Item 10.**Development Application: 816 George Street, Chippendale and 5220 George Street, Haymarket**

File No.: D/2018/1418

Summary**Date of Submission:** 23 November 2018**Applicant:** Sharetea Australia Pty Ltd**Designer:** Interior Life**Owner:** City of Sydney**Cost of Works:** \$150,000.00

Proposal Summary: Development application for the use of the existing building (former transport ticketing kiosk) as a takeaway food and drink premises. The proposed works include the installation of a serving counter, awnings, internal fit out, installation of signage and outdoor seating.

Figure 8: Proposed floor plan and outdoor seating

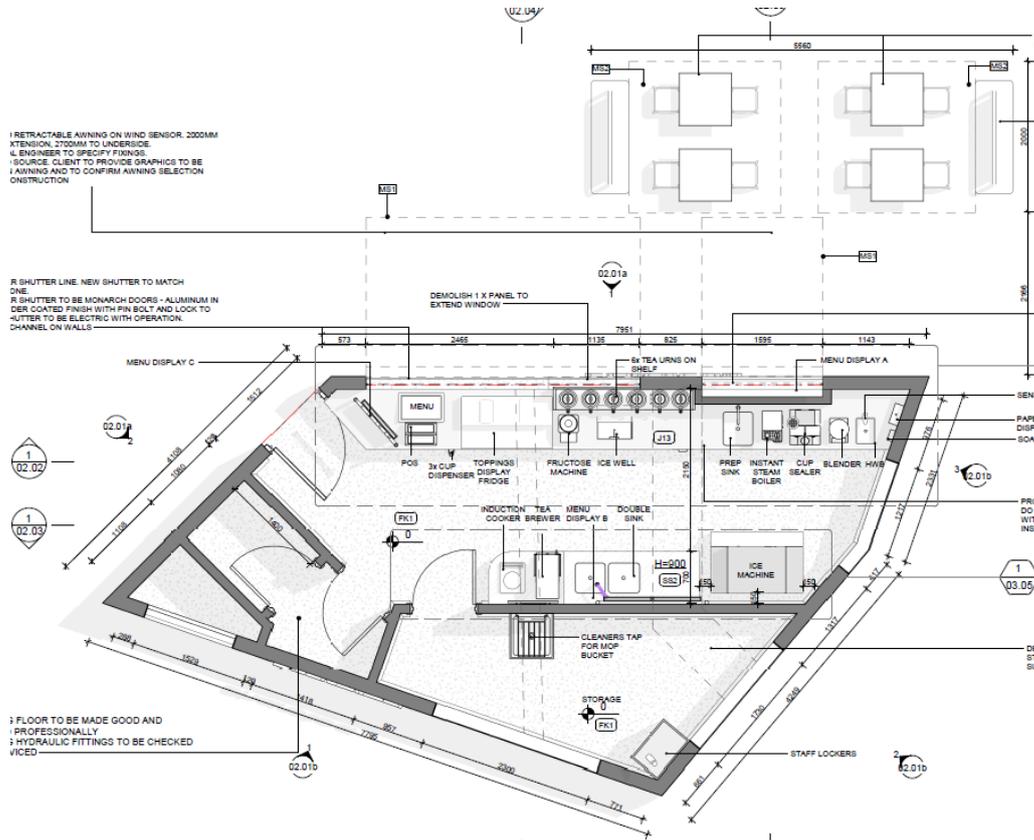
45. As discussed above, the outdoor seating which is shown on the proposed plans is located within the SP2 Infrastructure zone. Clause 42(2)(b) of the EPA Regulation provides that an expansion or intensification of an existing use can only occur on the land on which the existing use was carried out immediately before the relevant date and therefore the outdoor seating cannot be approved as part of the development.

47. Two fabric awnings are proposed to the primary front (north-east) elevation above the serving hatch and menu board. The awnings have a height of 2.1m to 2.4m above the public domain which does not comply with minimum height above the footpath in the DCP.
48. The proposed retractable awnings are not considered to exhibit design excellence as the material, form and external appearance does not improve the quality of the building appearance or public domain. A condition of consent is recommended which states that the proposed awnings are not approved and requires them to be removed from the plans.

53. Section 3.16.6.9 of the Sydney DCP 2012 refers to dynamic content signs and requires them to be entirely within a building and setback 0.3m from the glass line. The dynamic menu board is located on the front façade of the building on the existing roller door and does not comply with this provision. The sign is larger than 1.5sqm in area and occupies more than 20% of the opening to which it is to be installed contrary to section 3.16.6.9. No details of the animation have been submitted.

54. A design modification condition of consent is recommended which requires the graphic vinyl signs and dynamic content signs to be removed.
